IMPORTANT SAFETY RECALL - FMVSS 111-S9.3(c)

RE: 49 CFR 573.6 - Defect and Noncompliance Notification

Titan Bus Company, LLC has decided that a small defect, related to the safe operation of your school bus, exists in 2019-2021 Model Year Titan School Bus vehicles.

Figure 2A.

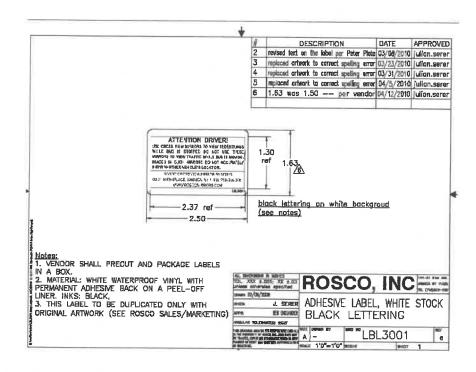
Titan SRW and DRW school and multi-function school activity bus did not meet the requirements of S9.3c for the Cross View Mirror Warning Label. When the average radius of curvature of a mirror is less than 889 mm, the bus must come equipped with a cross view mirror label. The average radius of curvature for the rearview mirrors were less than 889 mm, but the bus did not come equipped with a cross view mirror label.

Example of LABEL to be installed inside of vehicle within drivers view during normal operation.

Install the included label with this notice onto the vehicle with the associated VIN at the top of this page. The label should be placed in a conspicuous area that is visible to the driver while the vehicle is in operation.
